**Device**            **XC866-4FR**  
**Marking/Step**   **BE**  
**Package**           **PG-TSSOP-38**

This Errata Sheet describes the deviations from the current user documentation. The module oriented classification and numbering system uses an ascending sequence over several derivatives, including already solved deviations. So gaps inside this enumeration can occur.

XC866 User's Manual	V1.2	June 2006
XC866 Data Sheet	V1.0	Feb 2006

**INT\_XC8.004 Unable to Detect New Interrupt Request if Any One of Timer 2 Interrupt Flags Is Not Cleared (Unexpectedly)**

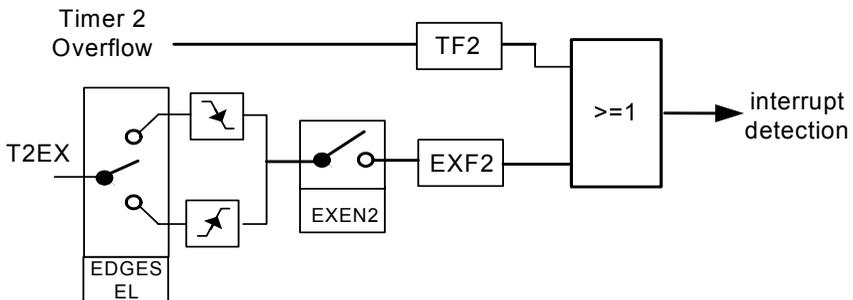
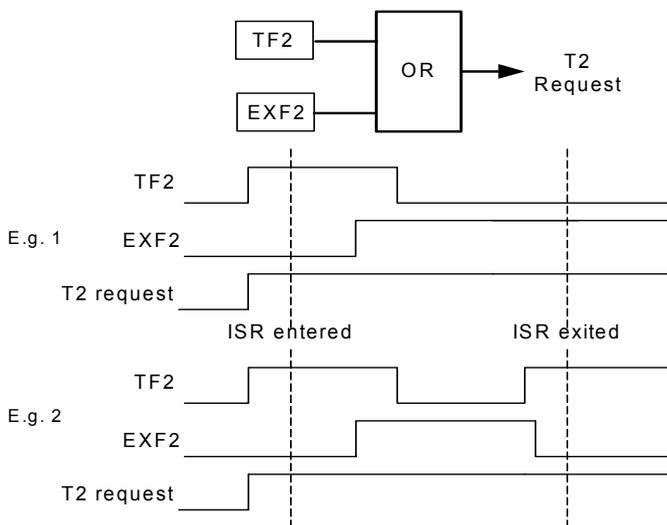
As illustrated in the simplified figure, the Timer 2 interrupt flags TF2 and EXF2 are combined as one interrupt request output. These flags are located within the Timer 2 kernel, with a single interrupt request line as output from the kernel.

The problem is that it may occur at some point in the application, that any new Timer 2 interrupt request can no longer be detected after a return-from-interrupt (reti) due to service of earlier event(s). This happens when the following conditions are true:

1. Timer 2 events are serviced by interrupt (i.e. flags are checked and cleared only in the interrupt routine ISR),
2. Either TF2 or EXF2 is set at any one time throughout the ISR (even while the other is cleared) such that at least one of the flags is still set after reti, causing the Timer 2 request line, which is an OR-function of the two flags TF2 and EXF2, to remain set throughout the ISR and after reti.

This means, any future Timer 2 TF2 or EXF2 event is not able to cause a rising edge and therefore not able to trigger an interrupt request to the core – as if the Timer 2 interrupts had been disabled, until both EXF2 and TF2 flags are cleared at some time. The clearing of flags would have to be done by user's code additionally outside of the Timer 2 interrupt routine, which is however normally not feasible with an interrupt service scheme.

There is no problem if EXF2 is not enabled by setting bit EXEN2 = 0 i.e. external events are disabled, or if bit DCEN = 1 in auto-reload mode.

Otherwise if EXF2 is enabled, while TF2 is always enabled when Timer 2 is running, there are two suggested workaround:

1. If other events of Timer 2 interrupt node (ET2) need not be enabled for interrupt, disable this interrupt node and use software polling of the flags instead.
2. Before return from interrupt, check again if TF2 or EXF2 is (still) set (due to new request since the last check). If so, jump and execute the ISR routine from start. Exit only when all flags are checked to be cleared. However, dummy interrupt of the node may occur after return from interrupt, and should be ignored. Another drawback is if Timer 2 events are occurring at high rate, the CPU may be 'stuck' in the service routine of the Timer 2 interrupt for a long time.

**INT\_XC8.H001 Interrupt Request With No Interrupt Flag Set**

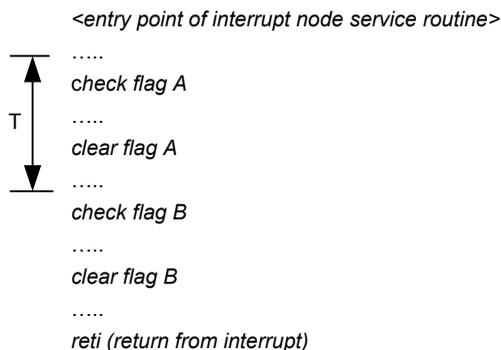
It might occur in the application, that sometimes interrupt requests are serviced, but no active interrupt flags are found. This would happen for those interrupt nodes which is shared by several interrupt sources.

Consider the following interrupt service routine pseudo-code, and scenerio where a interrupt source A event leads to interrupt request of the node and CPU vectors to the interrupt routine. Meanwhile, interrupt source B and its flag becomes active any time in the duration indicated by T:

In this case, flag B will be cleared as a standard procedure by the interrupt routine in the current service of the interrupt node. However, the pending interrupt request for the node remains activated after RETI, as it is only cleared

This leads to following servicing of the interrupt node again, but potentially no active flag is found, i.e. dummy interrupt service. The point to note is that the interrupt source B is not lost, as it was actually serviced in the current service of the interrupt node.

The recommendation is to ignore these dummy interrupt vectoring.

## INT\_XC8.H003 Interrupt Flags of External Interrupt 0 and 1

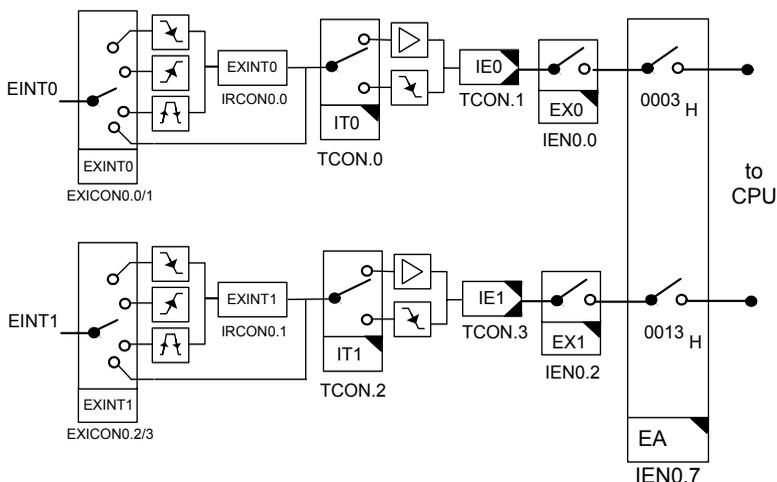
External interrupt 0 and 1 may individually be selected via respective bits ( $EXINTx$ ) in  $EXICON0$  register, to request interrupt on falling edge, rising edge, both edges or to bypass the edge detection.

Edge detection is done in the system unit. If enabled, an active event will set the  $EXINTx$  flag and correspondingly set the  $IEx$  flag in  $TCON$ . It should be noted that after any external interrupt  $x$  event, flag  $EXINTx$  must be cleared. In case of falling edge as active event, this allows any future active event to be able to set the flag  $IEx$  as interrupt request. In case of low level as active event, this prevents unintended recurring triggering of interrupt request.

In case of bypass edge detection, the input is connected directly to the core (bypass the system unit). The flag  $IEx$  in  $TCON$  will be set on the selected falling edge or low level (at least 2 clock cycles) event. In case of falling edge selected as active event by  $TCON.ITx$ , the flag  $EXINTx$  is set in addition to the flag  $IEx$ . However to use this mode properly, user must not clear the flag  $EXINTx$  and if necessary, to only access the flag  $TCON.IEx$  (refer to INT\_XC8.003).

1. The flag `TCON.IEX` will be set in all modes selectable via `EXICON0` register.
2. Flag `IRCON0.EXINTx` will be set in all modes as long as an active edge is detected; flag `EXINTx` will not be set for low level as active event.

1. Flag `IEX` is cleared automatically by hardware when the interrupt is being vectored to.
2. Flag `EXINTx` has to be cleared by software.
3. Clearing one external interrupt x flag will not clear the other. Especially, clearing flag `EXINTx` will not clear the flag `IEX`. Being of interrupt structure 1, the flag `IEX` is the request polled by the CPU for interrupt servicing. Therefore user has to take care to clear the flag `IEX` before switching from SW polling method to enabling the external interrupt x node, to prevent potential dummy interrupt request.
4. Always clear both `EXINTx` and `IEX` flags before (if) changing the trigger select in `EXICON0` register.
